Technical Service Bulletin

Subject: SQUEAK NOISE FROM RIGHT FRONT DRIVESHAFT	Bulletin No.: 03-002/18
	Last Issued: 09/05/2018

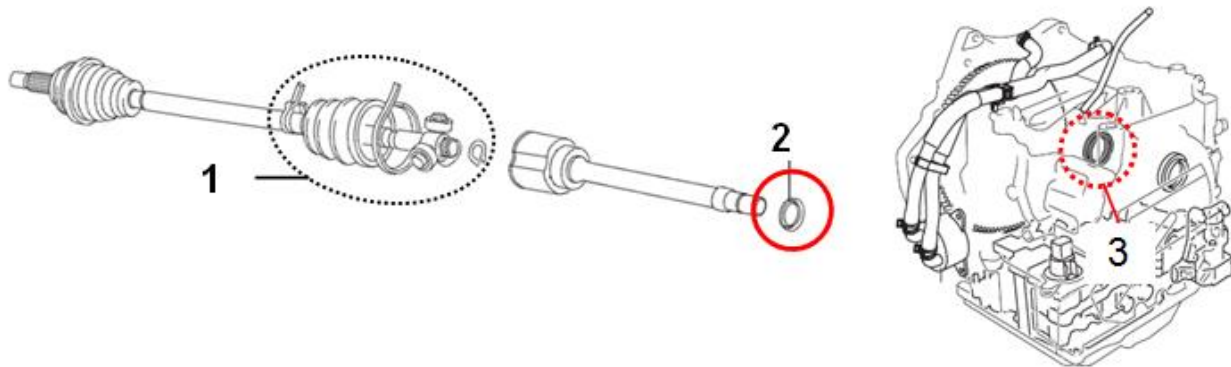
Some vehicles may exhibit a squeak noise from the right front driveshaft at the transaxle when driving. This concern is likely to occur when driving at speeds between 37-50 mph (60-80 km/h) with the ATF at normal operating temperature. The noise is caused by stick/slip between the oil seal at the transaxle and the dust cover of the driveshaft. To correct this issue, the thickness of the dust cover has been increased.

1. Verify concern
2. Replace the dust cover and the transfer oil seal with modified ones according to the instructions on MGSS (FRONT DRIVE SHAFT REMOVAL/INSTALLATION) and (FRONT DRIVE SHAFT (TRIPOD JOINT) DISASSEMBLY/ASSEMBLY).

1	Inner joint boot set
2	Dust cover
3	Oil Seal
